**DEPARTMENT OF TRANSPORTATION
STATE OF GEORGIA**

SUBJECT APPROVED CONCEPT REPORT

**DEPARTMENT OF TRANSPORTATION
STATE OF GEORGIA
PROJECT CONCEPT REPORT**

Encore Parkway from Westside Parkway to Northpoint Parkway
Streetscape and Big Creek Greenway Extension

TYPICAL SECTION NO. 1
 Encore Pkwy Widening Full Depth Section
 STA 103+50 LT TO NORTH POINT PKWY LT
 STA 103+50 RT TO STA 112+00 RT
 NORMAL CROWN OR SUPERELEVATED

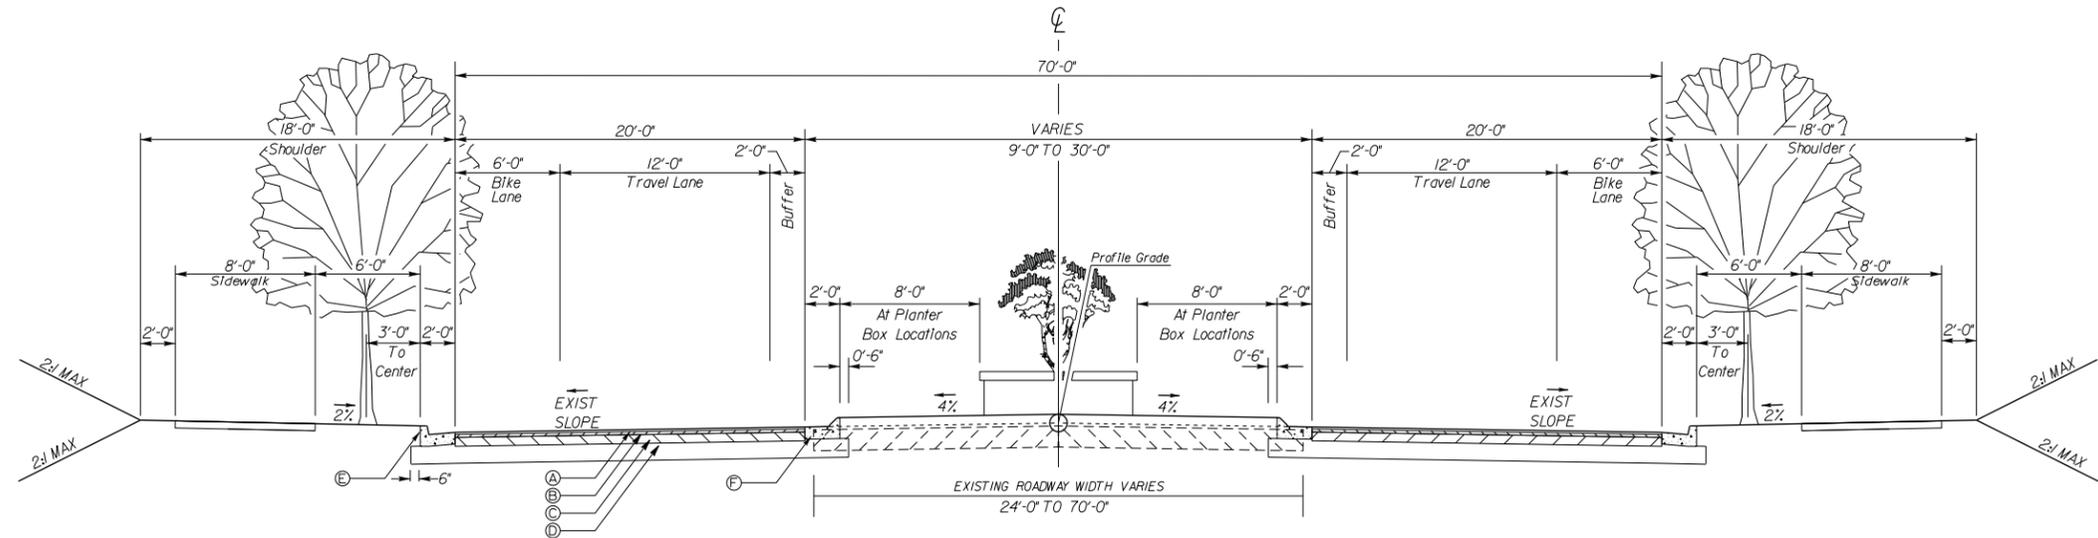
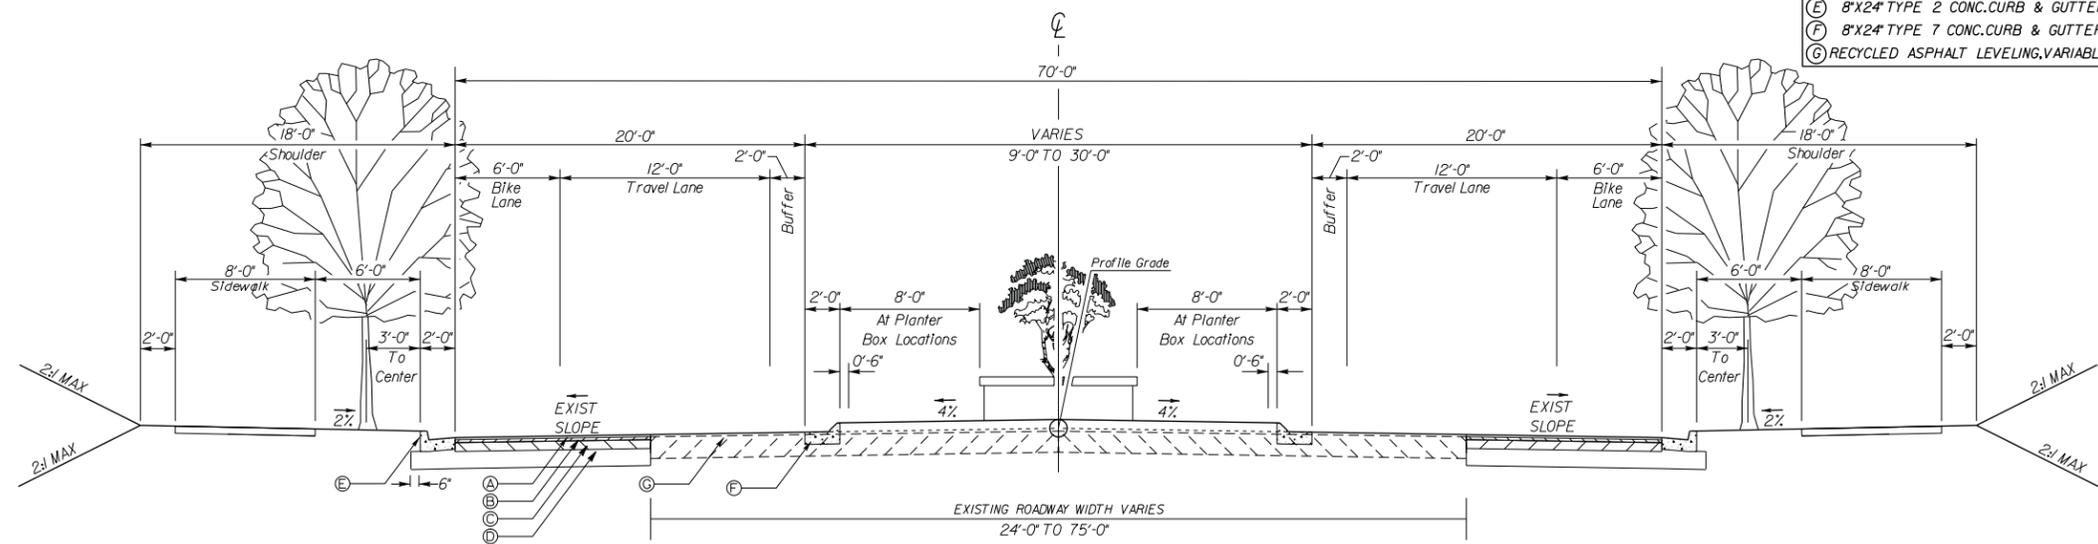
27	Typ Section	What is to be placed in median during “phase1” Should sidewalk/path at greenway have aggregate under the asphalt? Will maintenance trucks use the trail?	Plantings are to comply with GDOT Streetscape Manual.
28	Typ Section	For 4 lane section, indicate that the TS is for info only, proving the 4 lane can be addressed through the proposed Phase 1 dimensions.	The note has been added.
29	10	Items 5.and 6. shall be made available prior to the concept meeting for review.	The items are included.
30	Accident Analysis	This is a broad summary. Drill a little deeper. Are crashes concentrated at certain locations within the project? Intersections? DW's? How will the project address the higher than average statewide rates (3.5X, 1.5X)?	The accident analysis has been updated and includes intersections.
31		Is a sectional view required along SR 400 under the bridge to show clear zone/lateral offsets to the proposed future laneage?	The future laneage is shown on the future bridge concept layout in the concept report.

PLAN

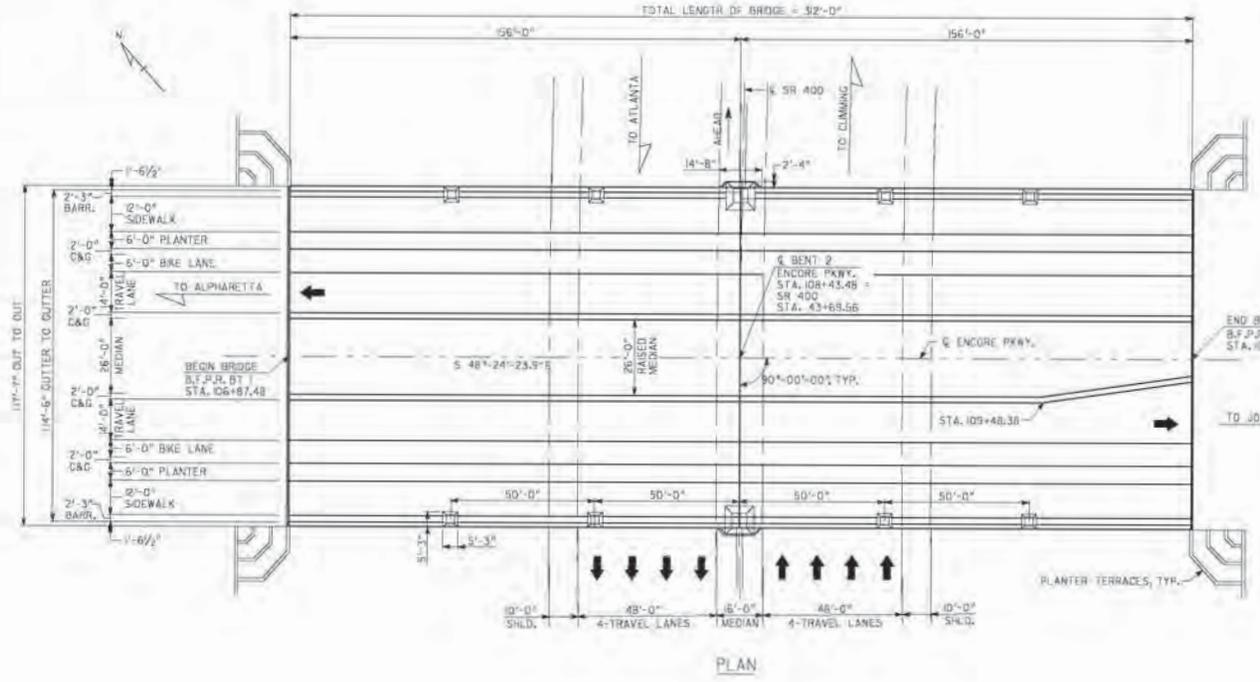
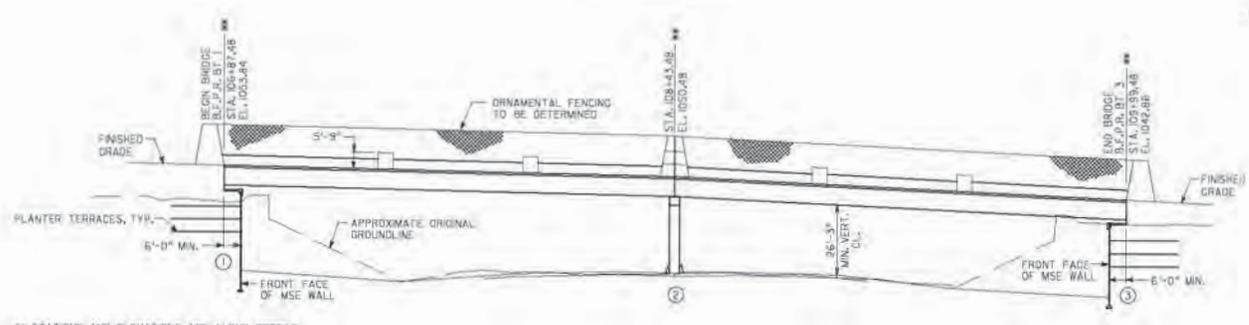
A-4	Eliminate the sixteen large internal planter boxes next to the sidewalk and reduce the width of the Encore Parkway Bridge	\$600,000	No	The planter boxes provide positive separation between the travelway and pedestrian areas. In addition, the planter box area is designed to match up with the planter strip area just off the bridge and maintain continuity throughout the project. This typical section conforms to the LCI study and the City of Alpharetta's 2008 Blueprint North Fulton Master Plan standards.
A-4.1	Reduce the width of the sixteen large sidewalk planter boxes, attach them to the parapets, and reduce the width of the Encore Parkway Bridge	\$300,000	No	The planter boxes provide positive separation between the travelway and pedestrian areas. In addition, the planter box area is designed to match up with the planter strip area just off the bridge and maintain continuity throughout the project. This typical section conforms to the LCI study and the City of Alpharetta's 2008 Blueprint North Fulton Master Plan standards.

A-7	Reduce the width of the Encore Parkway Bridge pilasters and make them line up with the inside part of the side parapet	\$80,000	Yes, partially	The pilasters will be retained as designed inside of the parapet, but will be reduced in width to line up with the outside of the parapet, which should result in the same savings.
A-11	Remove the eight large planter boxes from the median of the Encore Parkway Bridge and replace them with small boxes suitable for ground cover plants/flowers	\$40,000	Yes, partially	The width of the planter boxes will be reduced and the Designer will work with the Bridge Design Office to create a scaled-back compromise with smaller landscaping features.
A-14	Reduce the length of the Encore Parkway Bridge by eliminating the 50-foot end spans	\$1,000,000	Yes	This will be done to the extent possible. Further coordination with the SR 400 Managed Lanes project and MARTA will be required. The Office of Bridge Design will make a final determination after reviewing the preliminary bridge layout.

A-18	Reduce the width of the Encore Parkway Bridge by adding pedestrian plazas at the ends of the bridge in lieu of placing benches and wide shoulder areas on the bridge	\$400,000	No	The width of the bridge is set to coordinate with the sidewalk and planting strip locations off the bridge and to maintain continuity throughout the project. This typical section conforms to the LCI study and the City of Alpharetta's 2008 Blueprint North Fulton Master Plan standards.

Idea A-4: Eliminate the sixteen large internal planter boxes next to the sidewalk and reduce the width of the Encore Parkway bridge.

Idea A-4.1 Alternative to Idea A-4: Reduce the width of the sixteen large sidewalk planter boxes, attach them to the bridge parapets, and reduce the width of the Encore Parkway Bridge.

Idea A-11: Remove the eight large planter boxes from the median of the Encore Parkway Bridge and replace them with small boxes suitable for ground cover plants / flowers.

ARCADIS Response – Will not implement. The planter boxes provide positive separation between the travelway and pedestrian areas. In addition, the planter box area is designed to match up with the planter strip area just off the bridge and maintain continuity throughout the project. This typical section conforms to the LCI study and the City of Alpharetta's 2008 Blueprint North Fulton Master Plan standards.

ARCADIS Response – Will not implement. The planter boxes provide positive separation between the travelway and pedestrian areas. In addition, the planter box area is designed to match up with the planter strip area just off the bridge and maintain continuity throughout the project. This typical section conforms to the LCI study and the City of Alpharetta's 2008 Blueprint North Fulton Master Plan standards.

ARCADIS Response – Will partially implement. The pilasters will be retained as designed inside of the parapet, but will be reduced in width to line-up with the outside of the parapet, which should result in the same savings.

ARCADIS Response – Will partially implement. We will reduce the width of the planter boxes and will work with the GDOT bridge office to implement a scaled-back compromise with smaller landscaping features.

ARCADIS Response – Will not implement. The width of bridge is set to coordinate with the sidewalk and planting strip locations off the bridge and to maintain continuity throughout the project. This typical section conforms to the LCI study and the City of Alpharetta's 2008 Blueprint North Fulton Master Plan standards.
